Physical Protection  
Significance Determination Process

Proposed Rev. 1, dated July 26, 2000

# Physical Protection (Sheet 1)

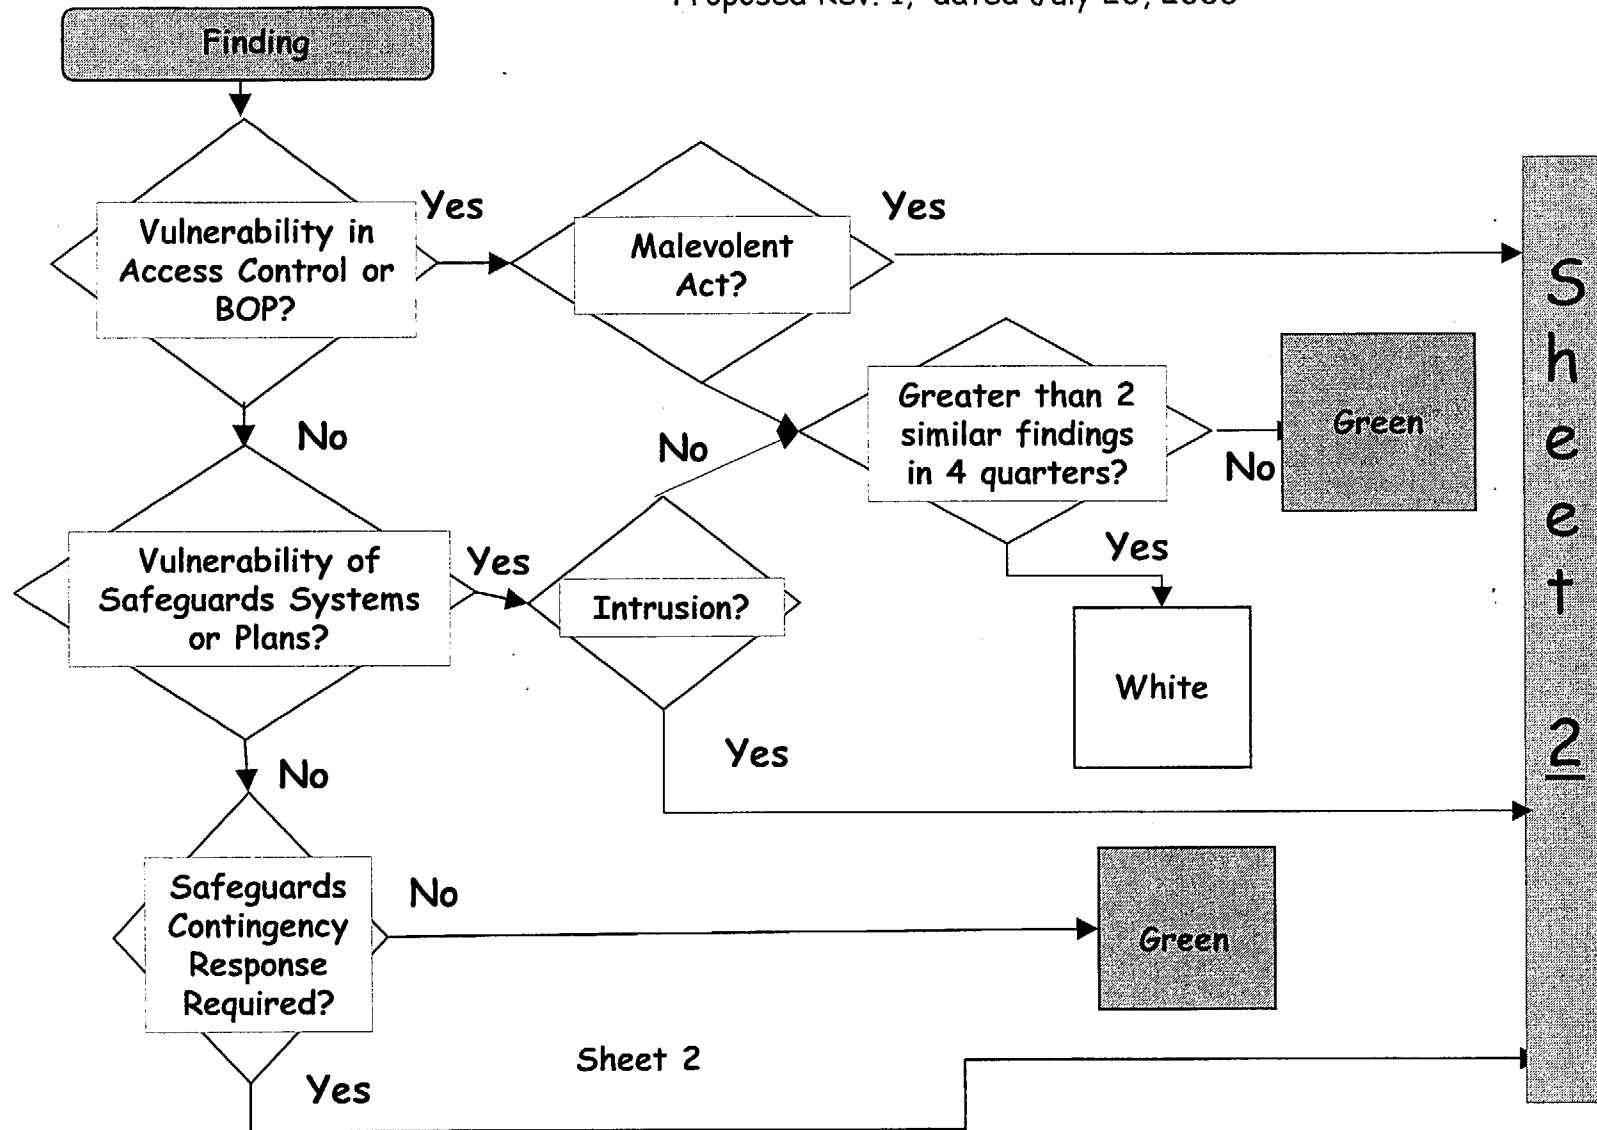
4. On Logic chart Sheet 1—Why does one branch block have "Intrusion?" while another branch block has "Safeguards Contingency Response Required?" if the first automatically leads to the second? Please provide some examples/scenarios using the thought processes expected for making determinations with these fault-trees.

# Physical Protection (Sheet 2) Significance Determination Process

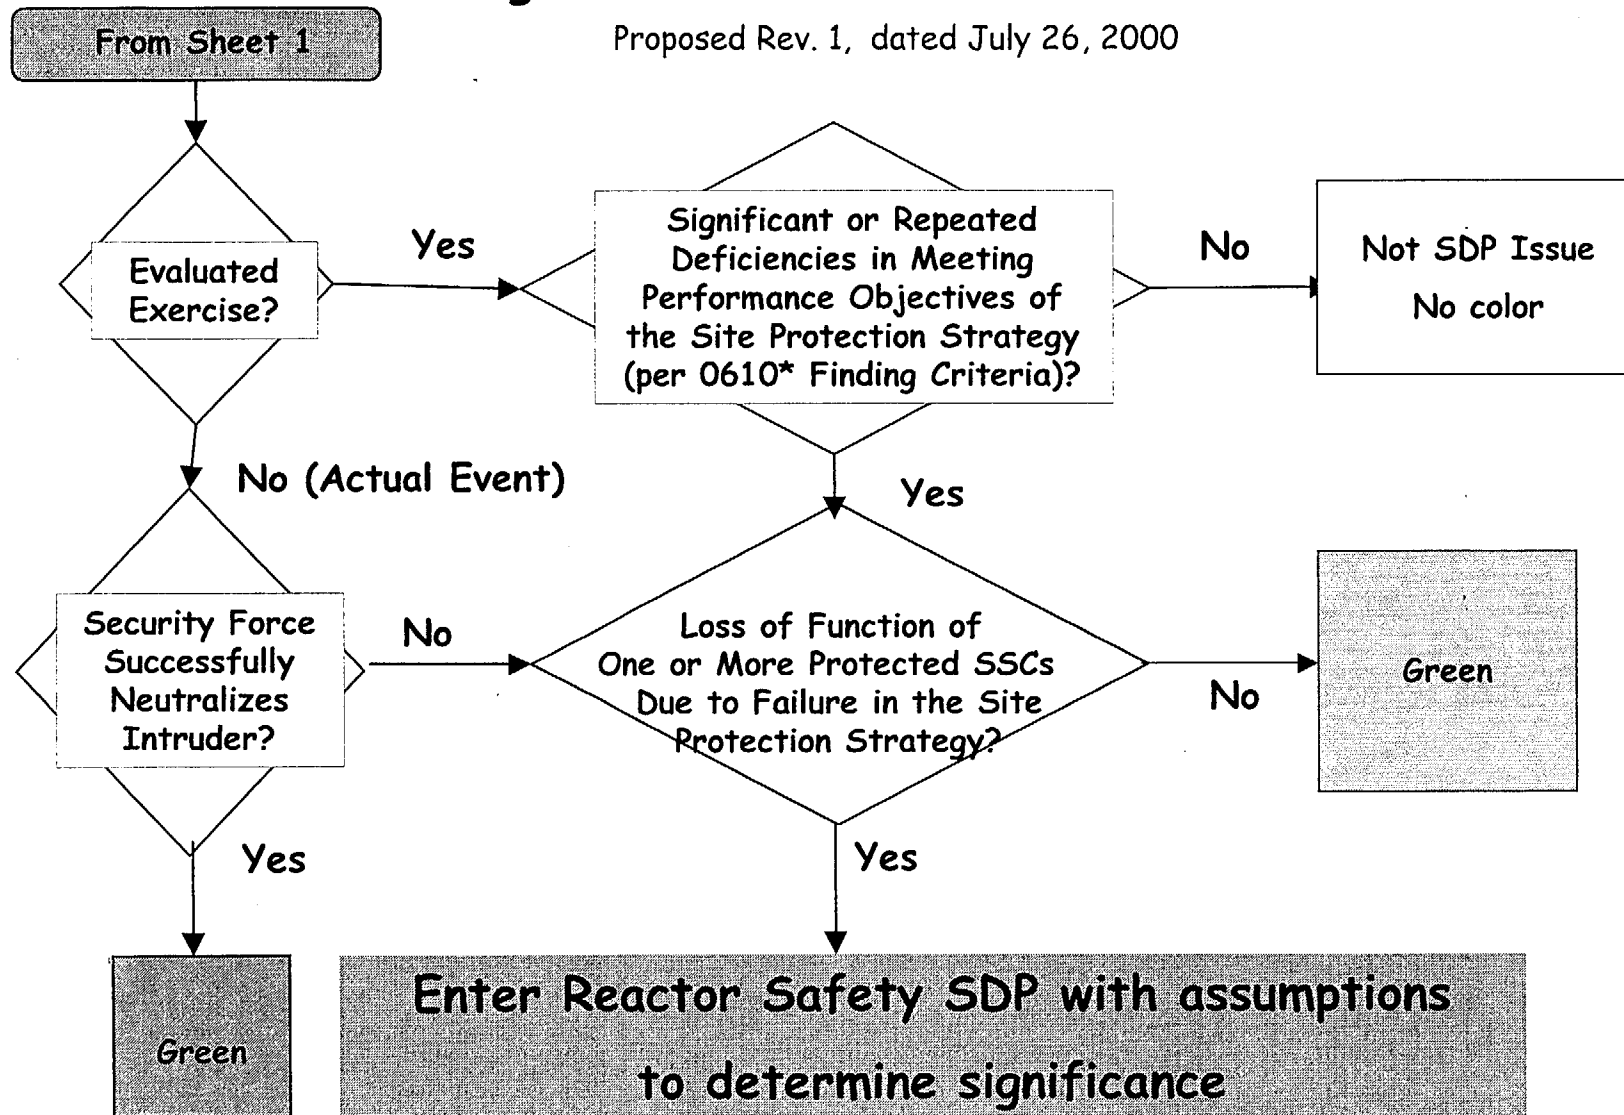
3. The Reactor SDP is entered (Logic chart Sheet 2) if there has been a loss of function of one or more protected SSCs due to failure in the site protection strategy. Does this mean that the protection strategy has failed if the function of one SSC is lost even though the strategy allowed for this occurrence by a fall back depth-in-depth strategy? If so, why?
